Calgary Crossing (Alca Coka & Maggie East)

CITY OF LAS VEGAS		DATE:
INTER-OFFICE MEMORANDUM		August 30, 2012
TO: Land Development Services Department of Public Works		FROM: Albert Sung, P.E. Flood Control Project Engineer Department of Public Works
SUBJECT: Drainage Study for: Calgary Crossing (A.K.A. Coke & Maggie East)		COPIES TO: Taney Engineering
Cross Streets:	NEC of Coke and Maggie	D. R. Horton Inc.
File Number:	F:\Depot\DSMemos\DS3796H.doc	Bart Anderson, P.E., DevCo
Parcel Number:	125-09-501-003	
Zoning Action:	SUP-4558, TMP-6237 & VAC-13158	
FEMA Flood Zone	YES NO X	
Proposed Storm Drain	YES X NO

RE: Park Ranch Estates Revision (Delta 4)

ORIGINAL CIVIL PROJECT #: 109260 19120 DATE: 7/26/12
PROJECT NAME: Park Ranch Estates Calgary Crossing
DRAWING NUMBER: 10744958 **RECEIVED**
ENGINEERING FIRM: Taney Engineering PHONE #: 702-362-8844 JUL 26 2012
ORIGINAL P.E. FOR THE PROJECT: Michael Bailey City of Las Vegas
DEVELOPER: D.R. Horton Land Development

GRADING PLAN

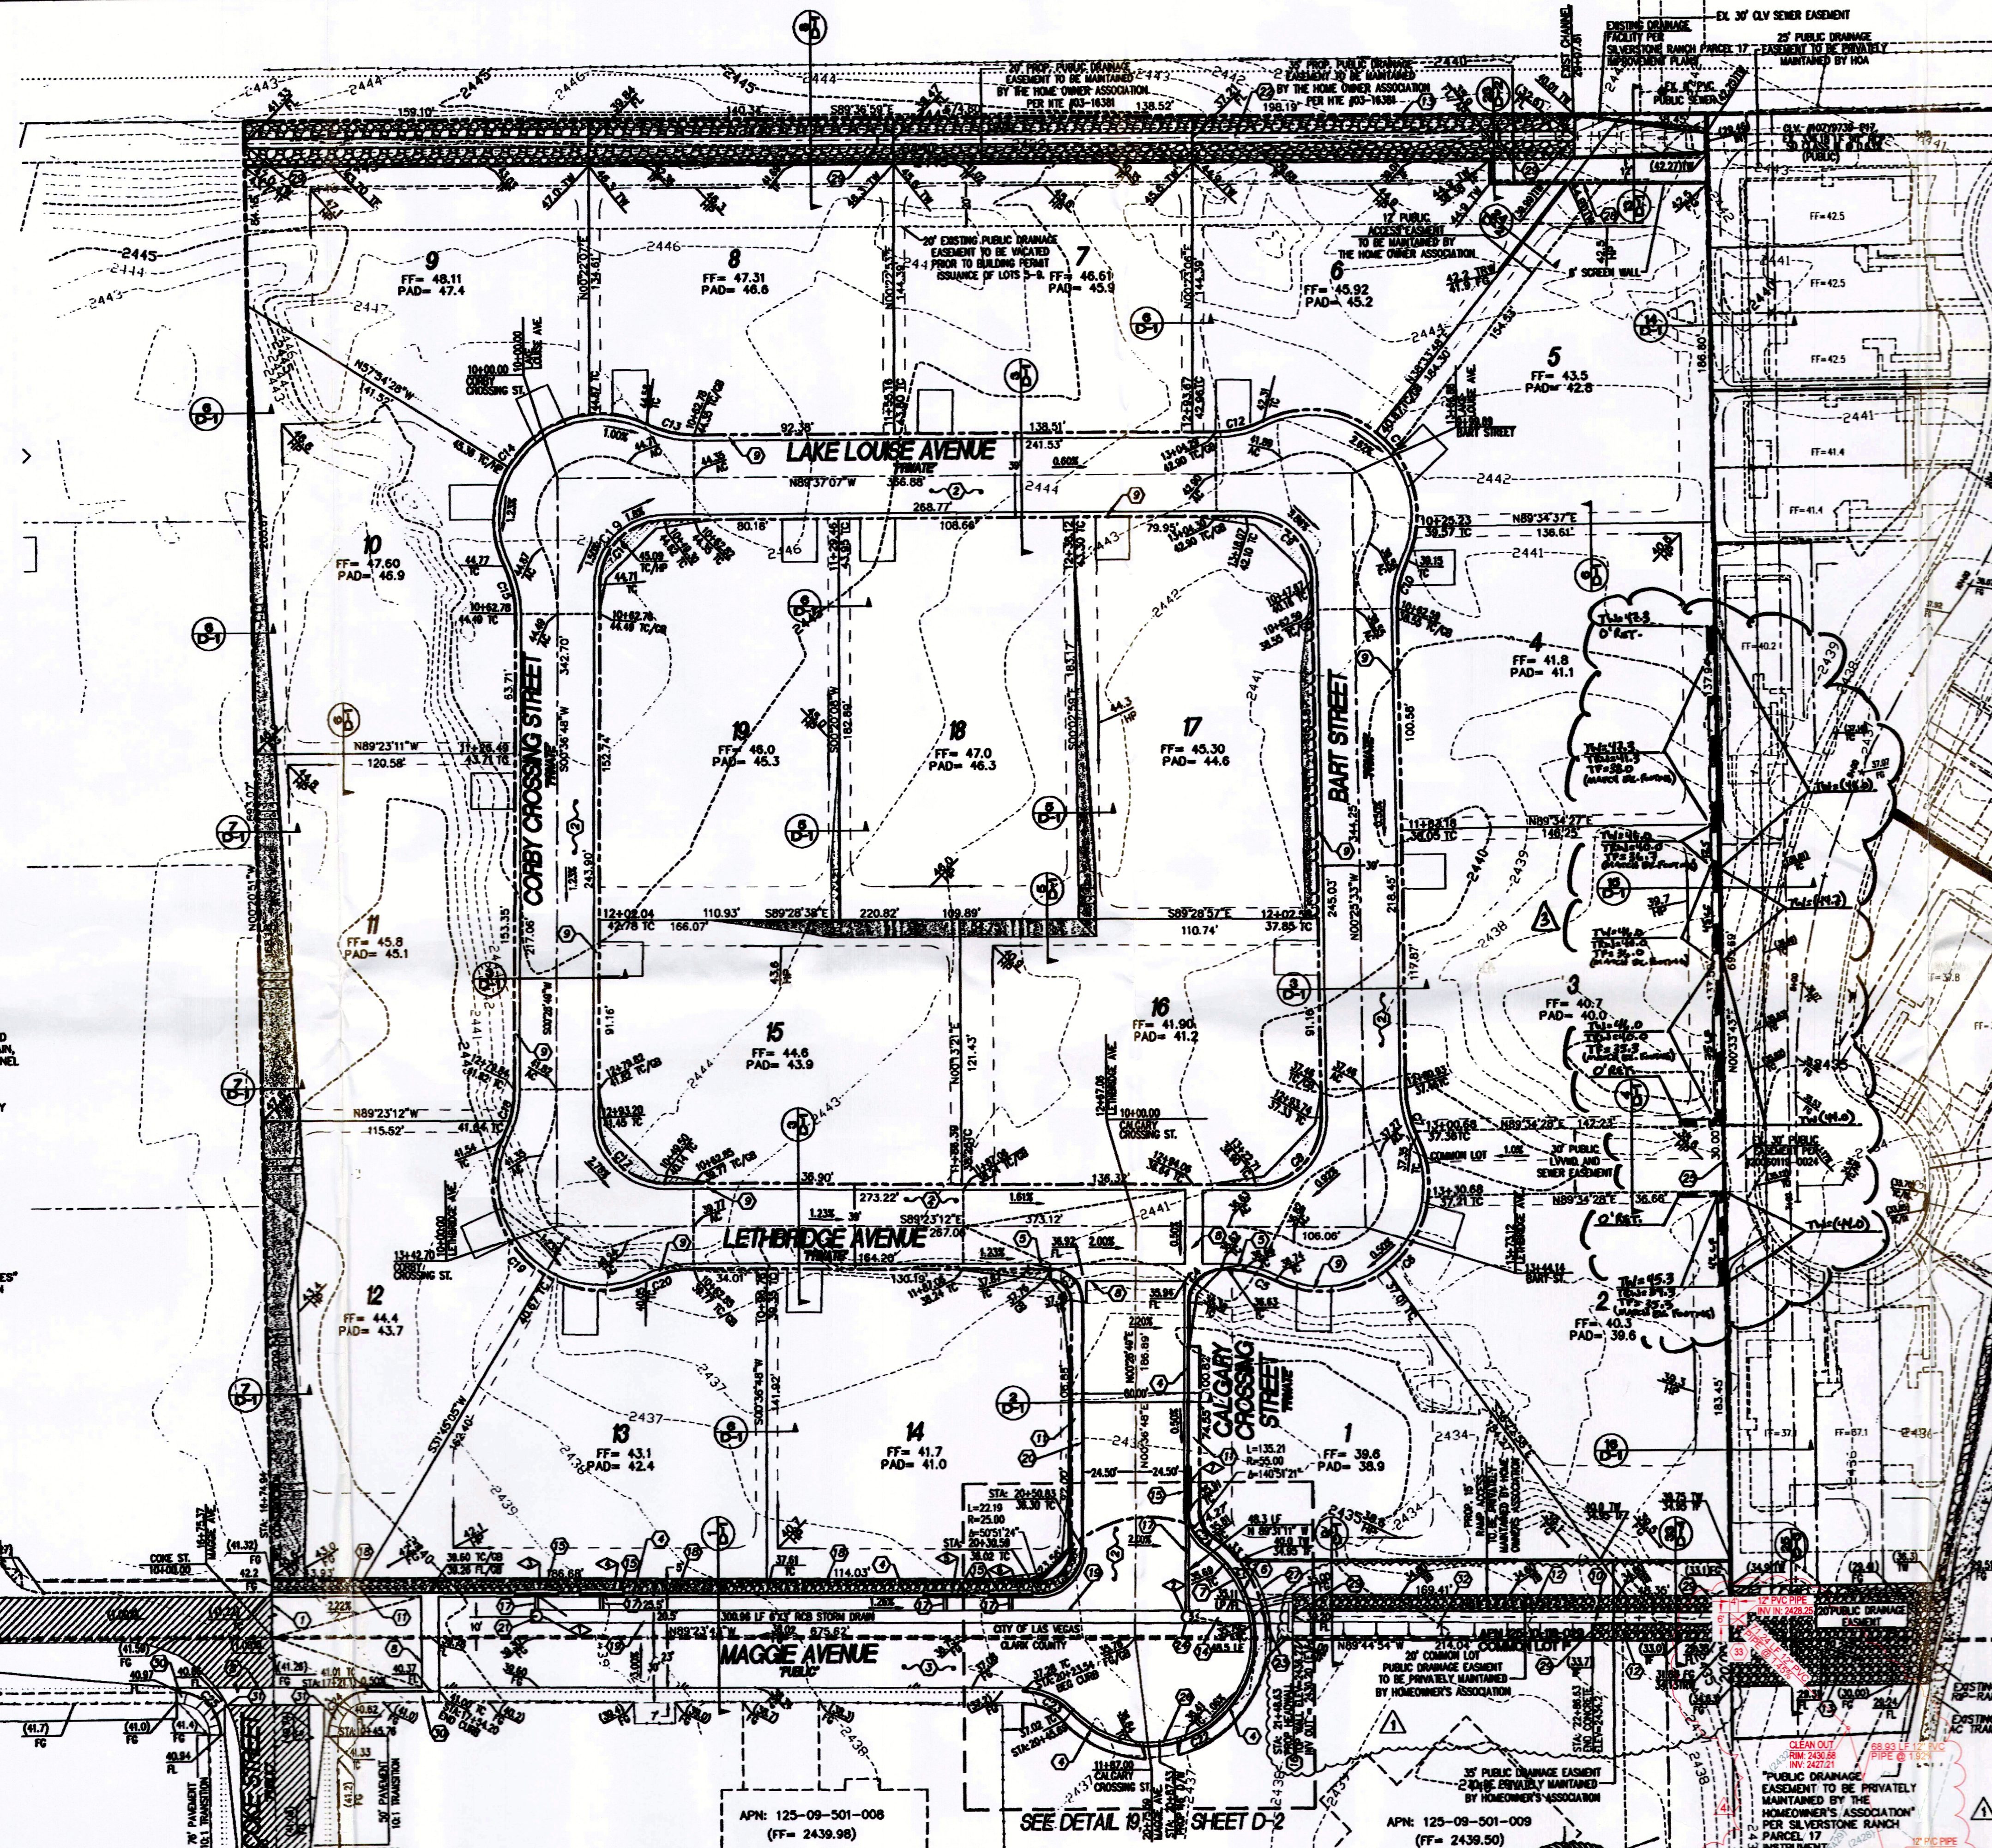
The revision is good. However, we would like the developer to upsize the proposed 8" nuisance pipe to 12" diameter. Lastly, provide a 10'x10' riprap pad at the end of the pipe for erosion protection.

- ① Provide a ~~detail~~ of construction detail
at the entrance of the proposed
8" PVC.
- ② Protect the PVC with
Type 2 encasing.
- ③ Show existing F.G. or Contours to
verify daylighting of the pipe
- ④ May need a sidewalk underdrain
a distance beyond the daylight point
- ⑤ Golf Course Permission.

NOTE: CONTRACTOR TO INSTALL CONCRETE APPROX. 10' DRAIN INTO 12" PVC PIPE. 6" CONCRETE OVER COCONOT TYPE II. SEE DETAIL A ON SHEET D-1.

PLAN AND PROFILE- MAGGIE AVENUE AND STORM DRAIN
CALGARY CROSSING
BARTON K. MAYBIE
CITY OF LAS VEGAS

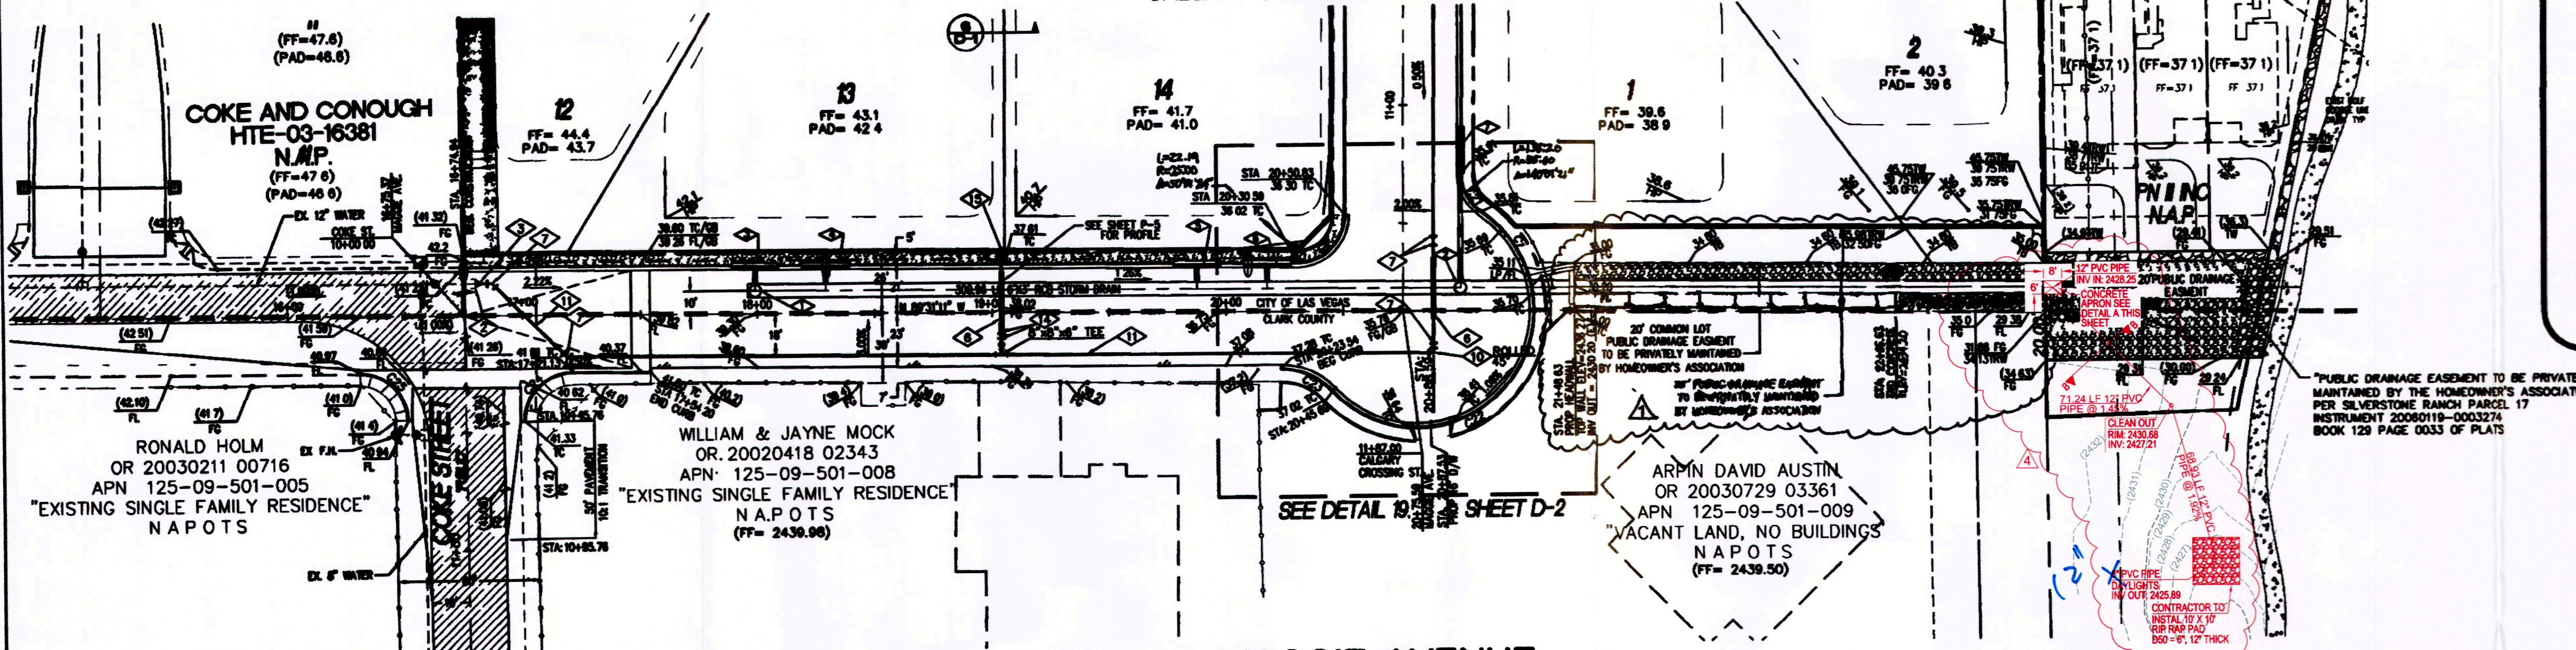
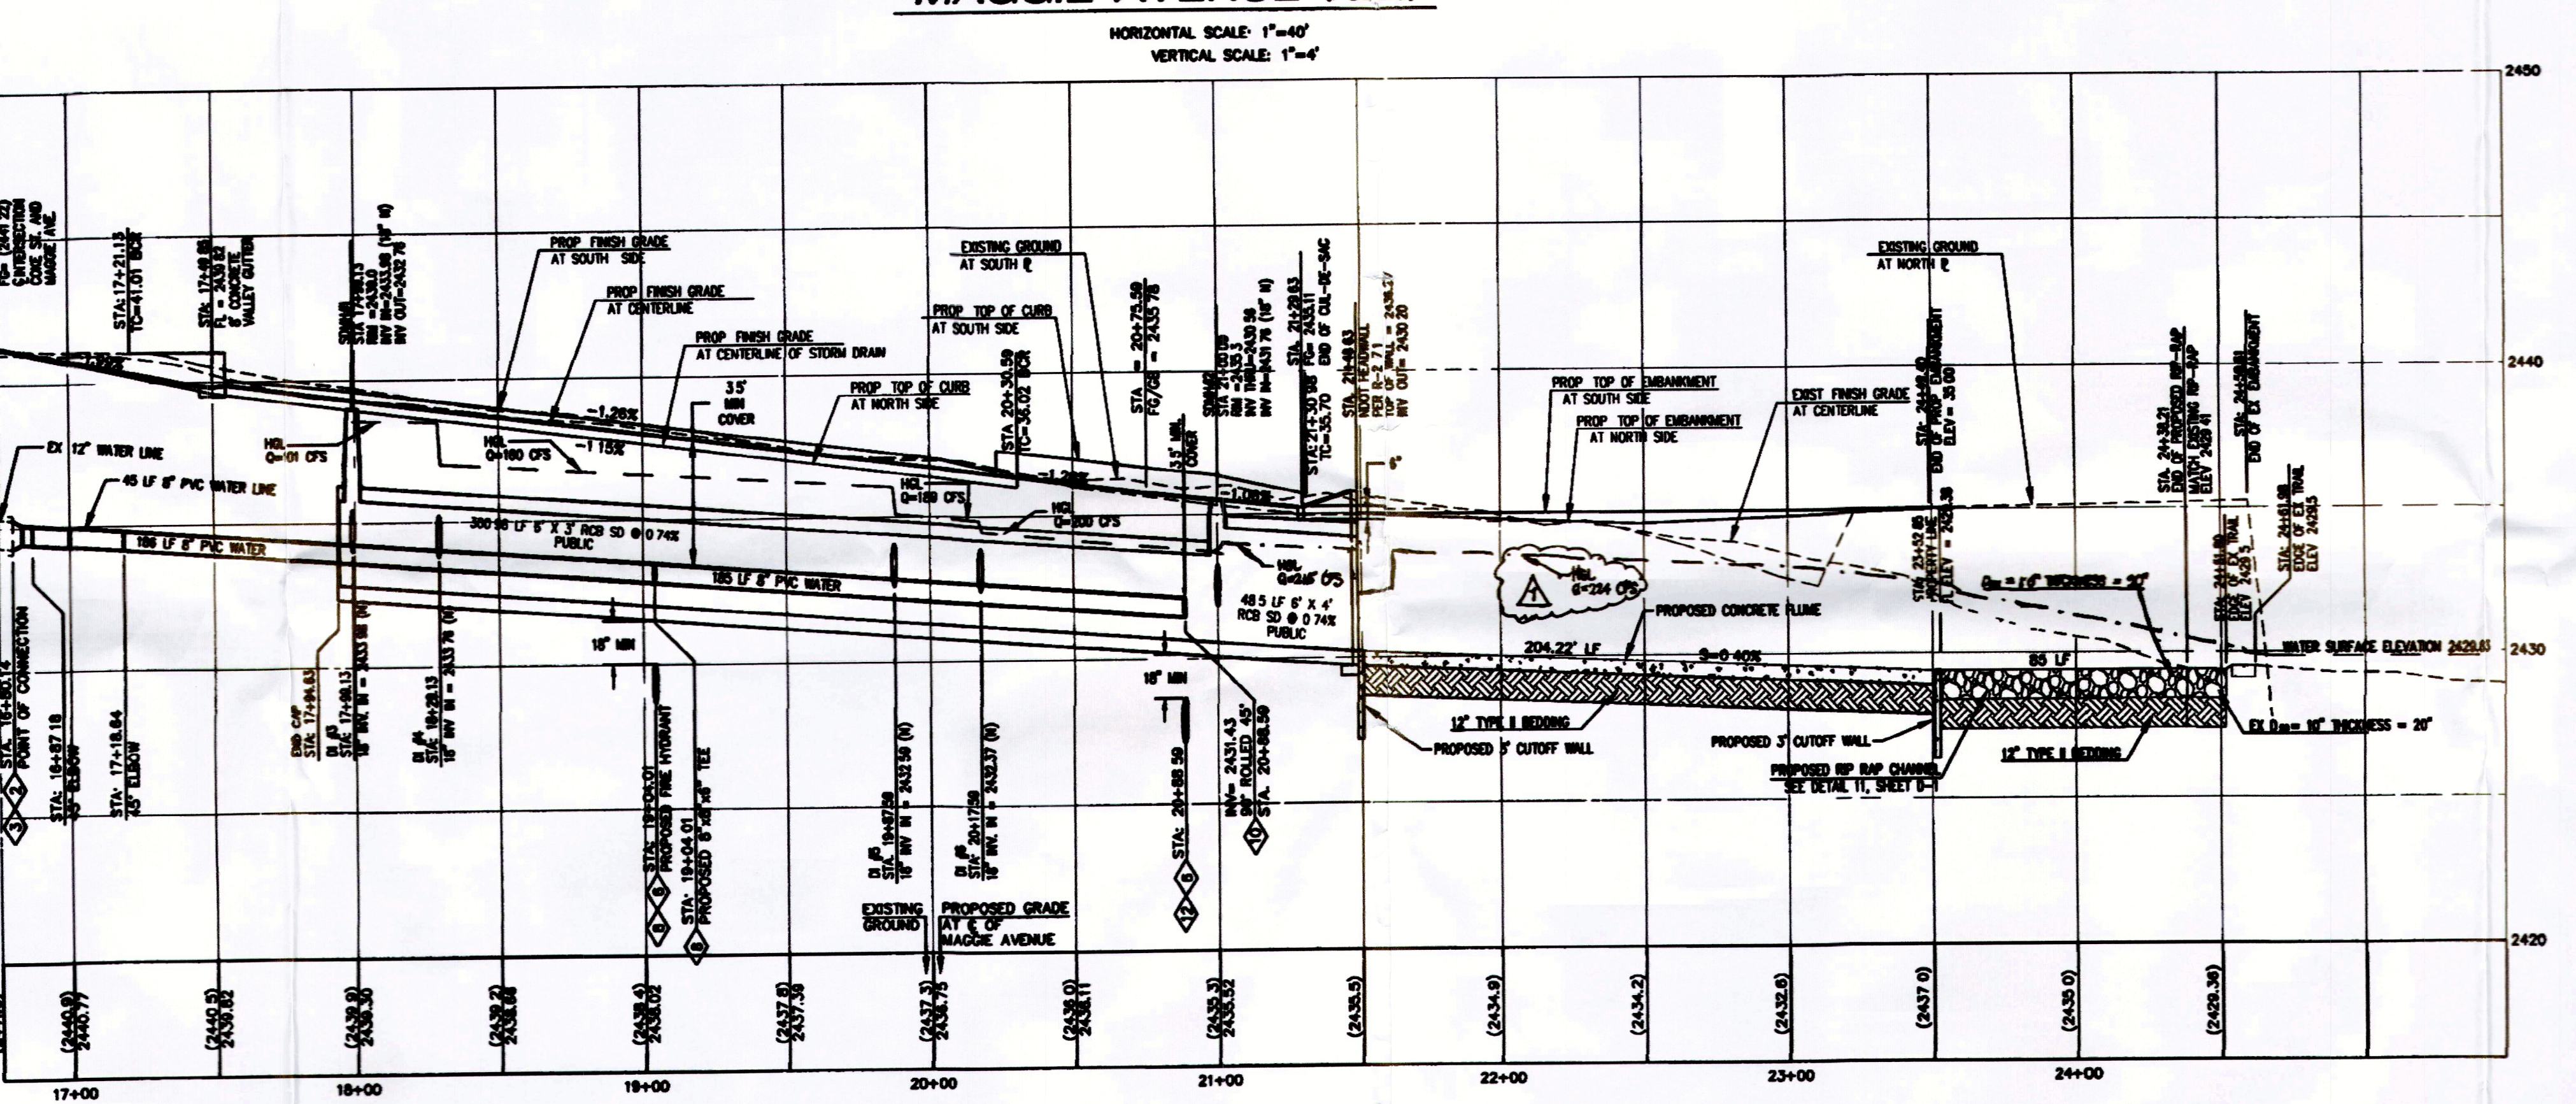
Sheet(S) 3, 4, & 5 Requested by: D.R. Horton
Reason: Added an 8" PVC pipe that daylights into the drainage
easement. PART OF FINAL PUNCH LIST ITEMS TO BE ADDRESSED.

DATE	DESCRIPTION
3-4-06	REVISED CHANNEL LAYOUT & ELEVATIONS
8/28/12	REVISED PLANS TO ADD 12" PVC PIPE IN THE DRAINAGE EASEMENT
